Hanna ECHS New Gymnasium Facility – CSP 20-110

ADDENDUM NO. 3

July 9, 2019
BISD Hanna Gymnasium Facility

ADDENDUM NO. 3

Date: June 12, 2019
Scale: As Noted
Project Architect: David Monreal, AIA
Drawn By: ETHOS
Job No: BISD Hanna Gymnasium
Sheet: **E4.01**

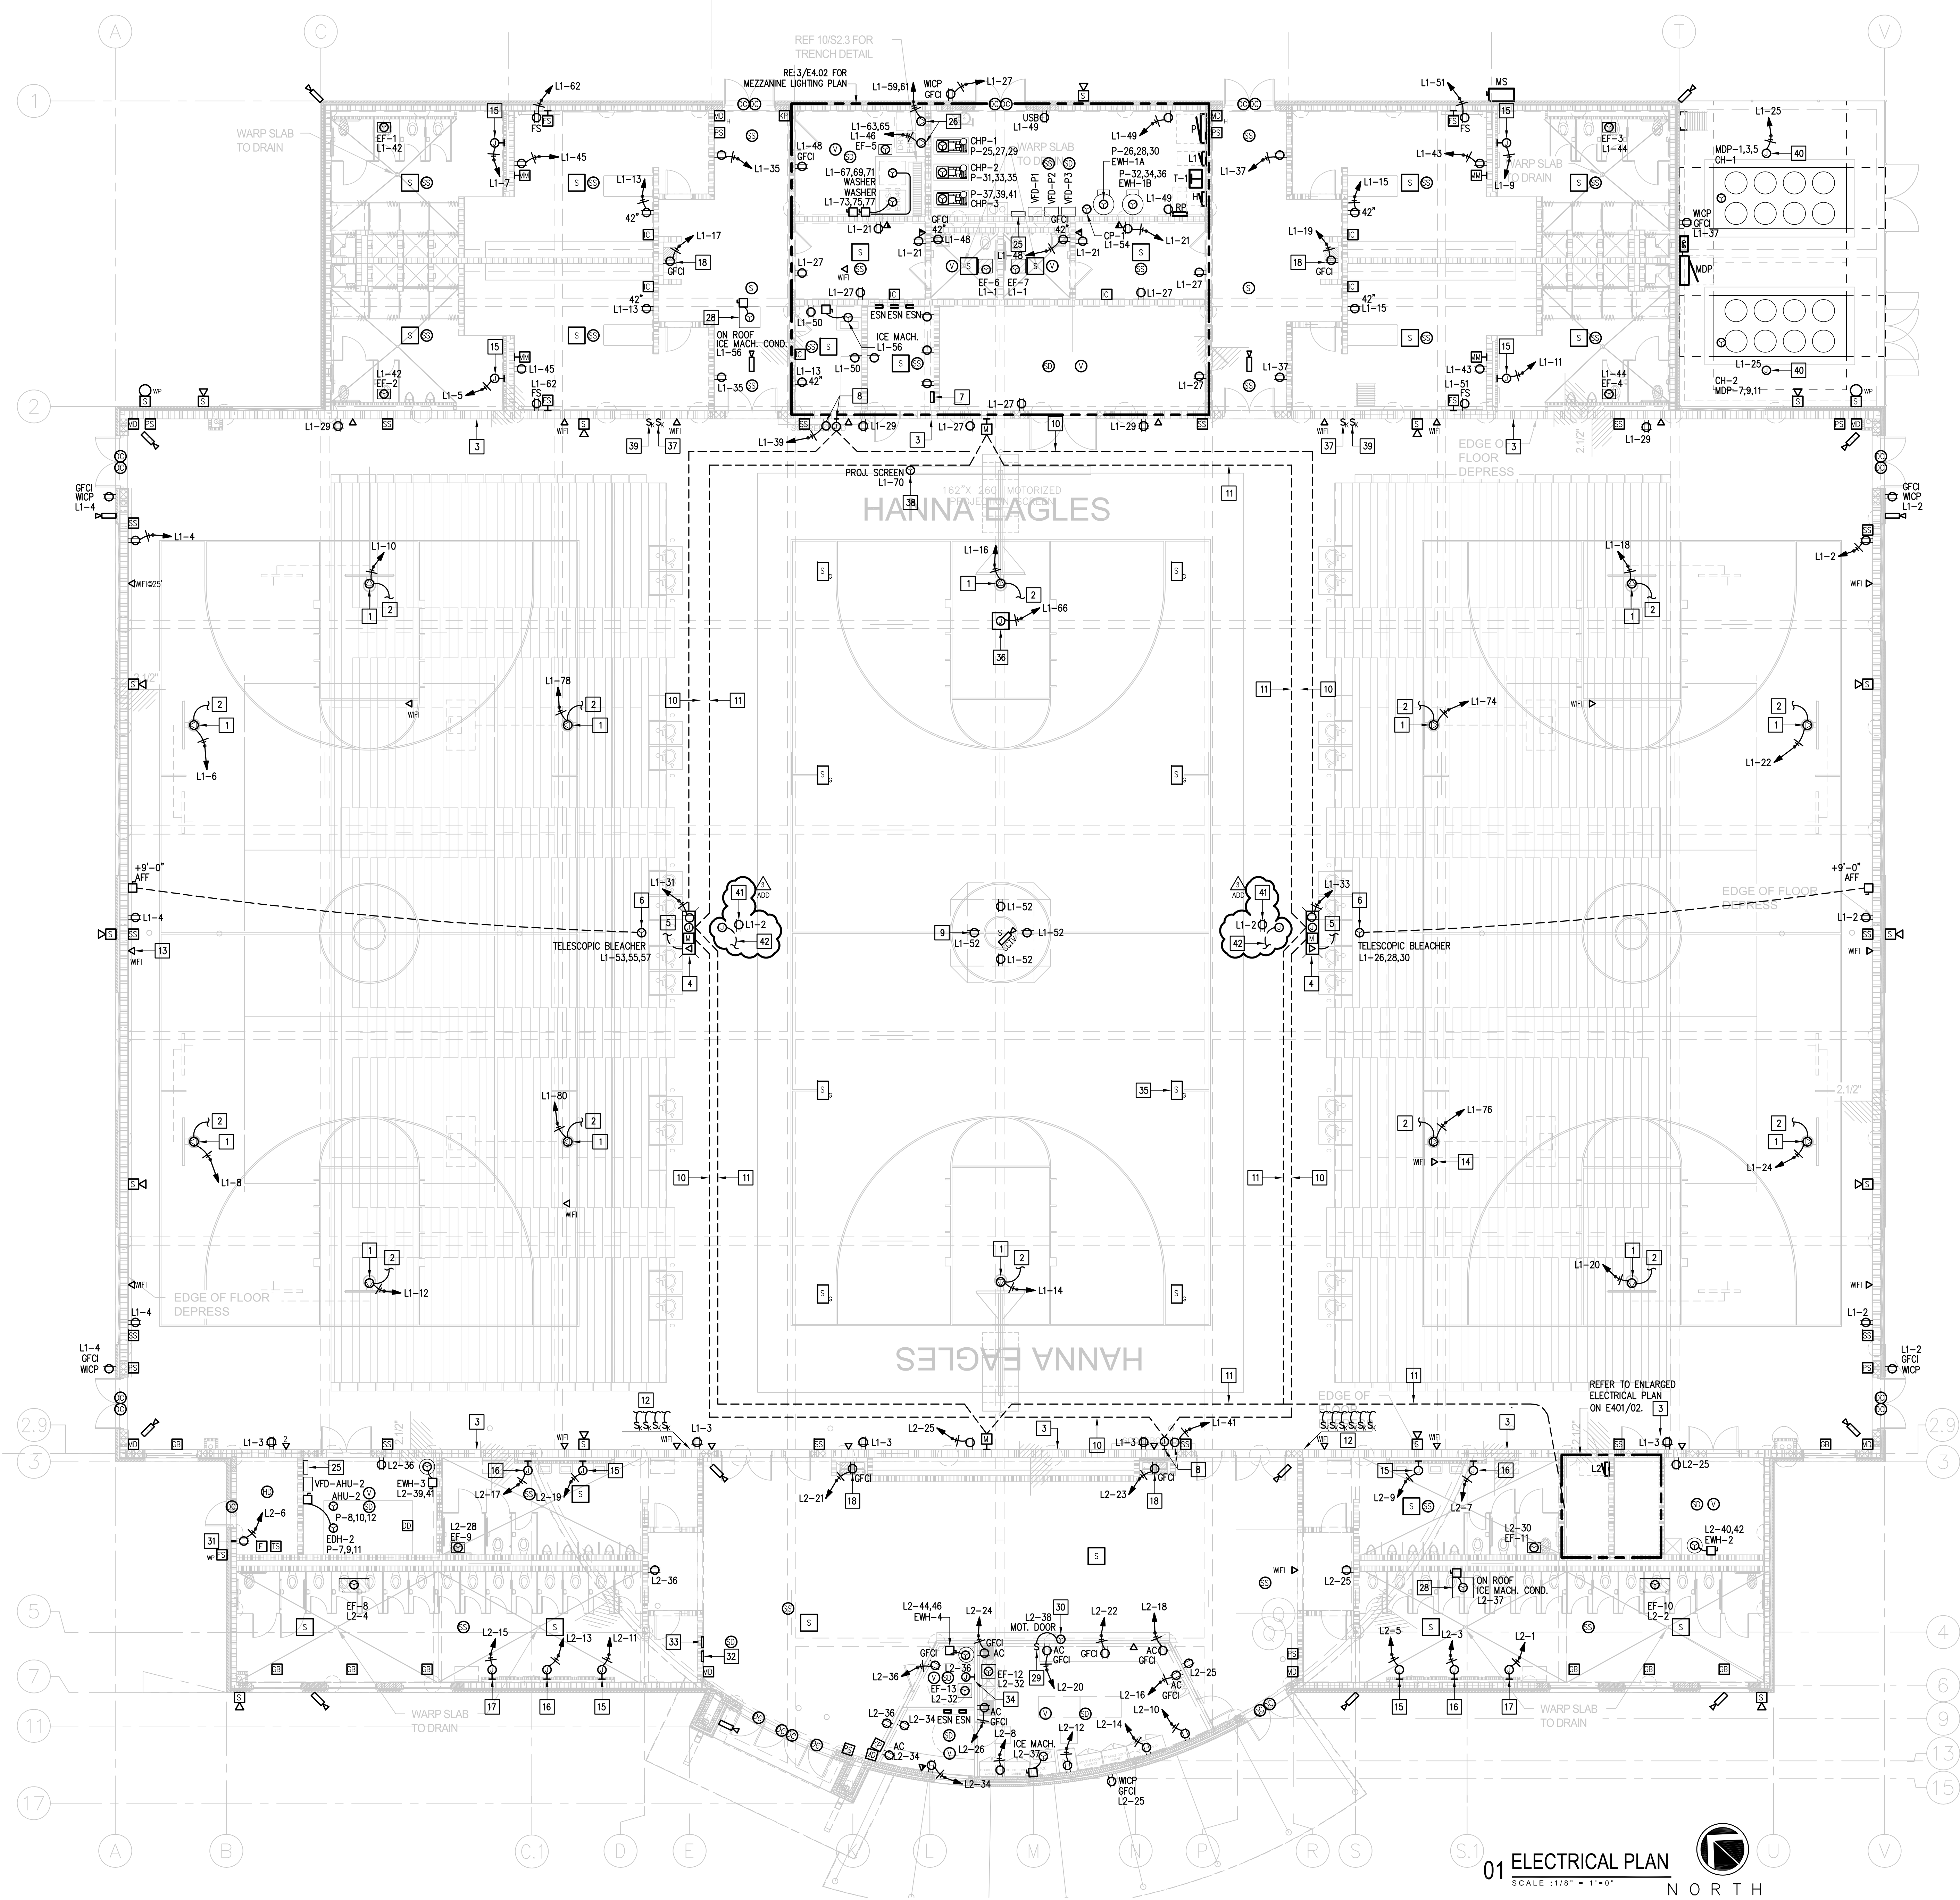
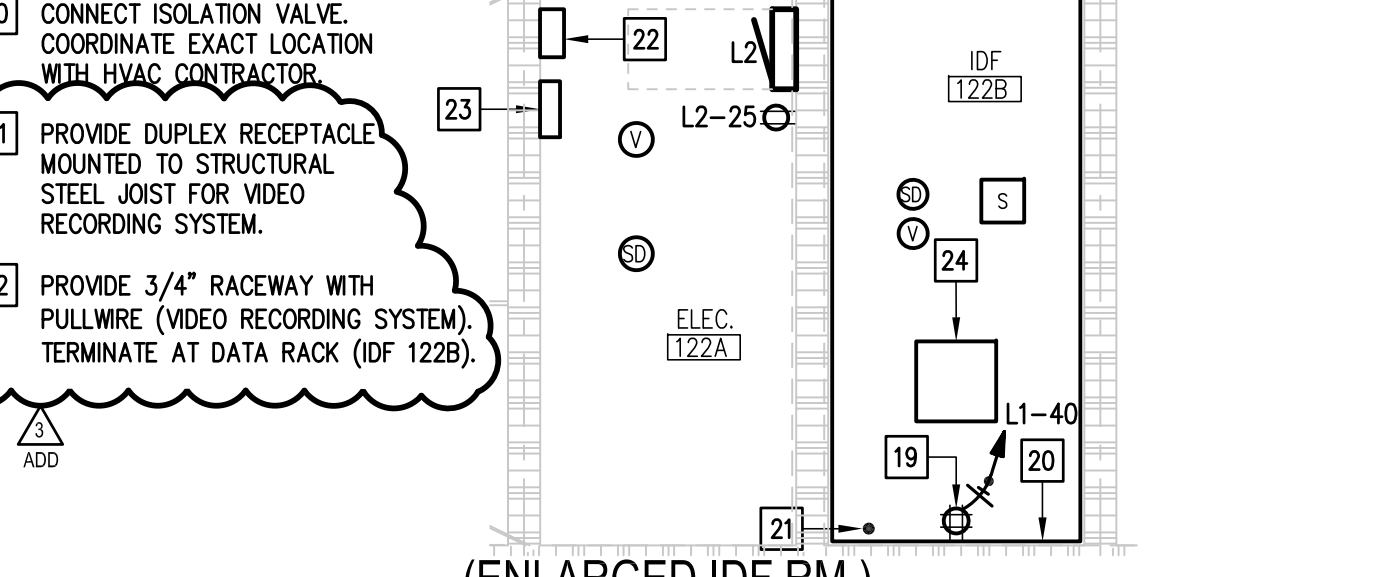
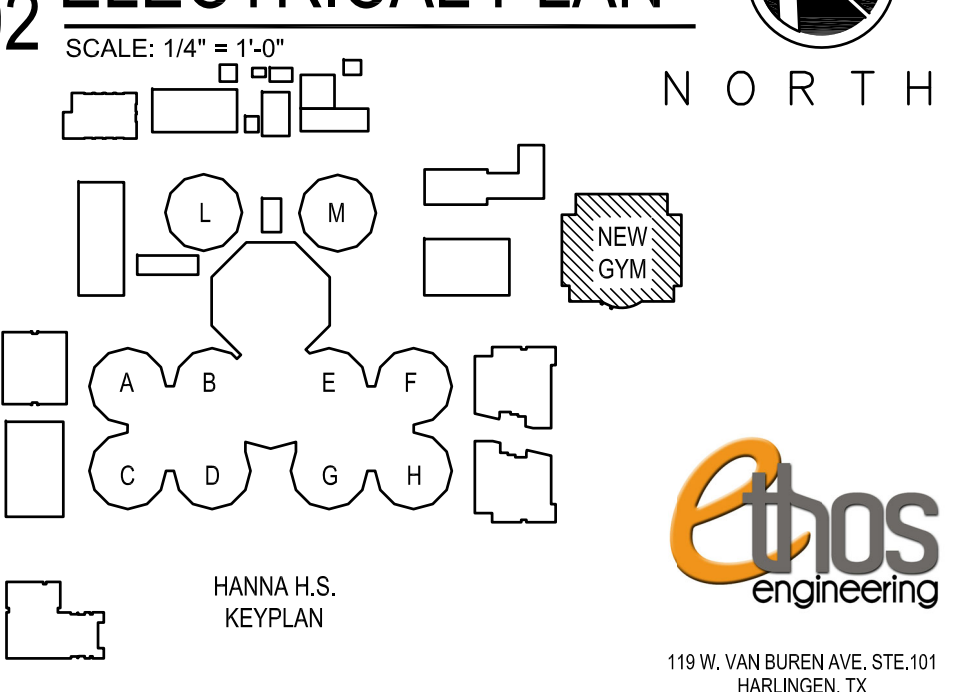
- 2) Sheet E4.01:
 - a) Revised Electrical Plan for video recording system provision. See attached sheet.
